JAE Electronics, Inc. · 142 Technology Drive #100 Irvine, CA 92618 · Ph. (949) 753-2600 · Fax (949) 753-2699 · www.jae.com

Material Change Notice:
DX4 Receptacle

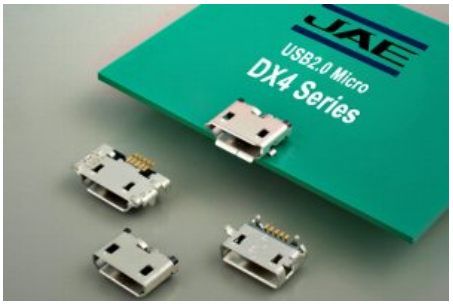
Due to the discontinuance of the material currently being used, the insulator for the following DX4 receptacle parts will be changing per below:

Part Number	SJ Drawing	Insulator Material Change
1	DX4R005JJ2R1800	**SJ110579**	**Current Material:** **35% GMF LCP TYPE IX SELCION KC173W** **New Material:** **35% GMF LCP TYPE UENO LCP UX101**
2	DX4R005HJ5R2000	**SJ111771**	
3	DX4R005JJER1800	**SJ114662**

There is no change in connector performance or SJ drawings.
